*Comment Received From: Gary Klein & Nick Brown
Submitted On: 5/7/2024
Docket Number: 24-BSTD-01*

Heat Pump Water Heater provisions

From: Gary Klein, Gary Klein & Associates and Nick Brown, Build Smart Group

FIGURE 12. HPWH EFFICIENCY IN ENCLOSED SPACES

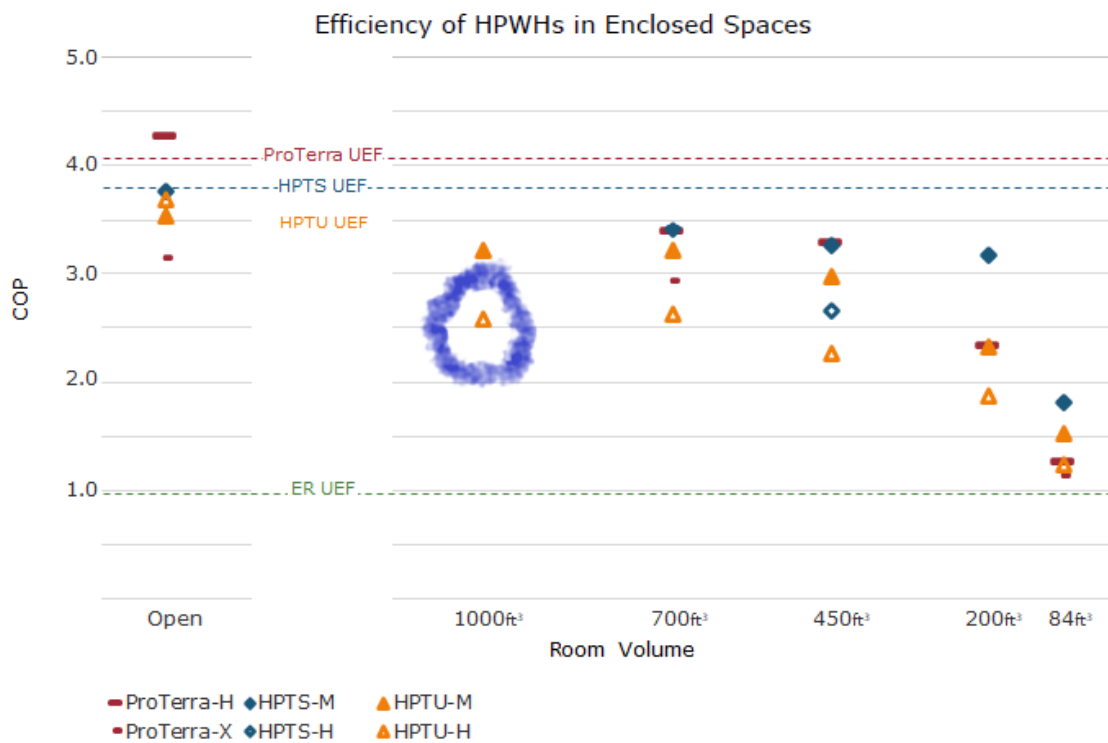
We calculate that the minimum space volume that has been proposed is insufficient; and the space required without access to external air likely needs to be significantly above 250 cubic feet per kBtu/hr in order for the HPWH to operate primarily in heat pump mode, rather than resistance mode. This is based on Larsen and Gantley's report "Laboratory Testing of Heat Pump Water Heater Performance: Impact of Airflow and Space Configurations" sponsored by PG&E, December 2023. The circled data point for the AO Smith unit with high draw pattern (85 gallons per day) shows COP of 2.5 at 1,000 cubic feet with a 4,000 btu/hr heat pump. Any enclosed space reduces the COP. The higher the draw pattern in an enclosed space, the lower the COP in heat pump mode, until eventually, the hybrid HPWHs switch to resistance mode with a COP of 1. A key reason for the lower efficiency is that as the intake air for the heat pump gets colder, it is harder to extract energy from the air. Hence, we propose the 250 cubic feet per kbtu/hr minimum requirement to allow for high draw patterns in enclosed spaces. Note that this allows for installation in one-car garages for typical hybrid HPWHs and in two-car garages for 12kbtu/hr HPWHs, without added ventilation in either of these two spaces.

An unintended consequence of enclosed spaces is to limit the amount of hot water that can be made in heat pump mode. This is due to two factors: how much energy can get into the room via conduction only and how many hours the HPWH can operate in heat pump mode inside this room.

Again, referencing the Larsen/Gantley report, for every 2 hours the HPWH runs in heat pump mode, the room takes at least one hour to recover the heat that has been extracted. And this was based on the space surrounding the enclosed room always being warmer, so heat could flow inwards via conduction, implying that this only works when the HPWH is installed inside a conditioned envelope. This means that the heat pump can only run 16 hours out of every day.
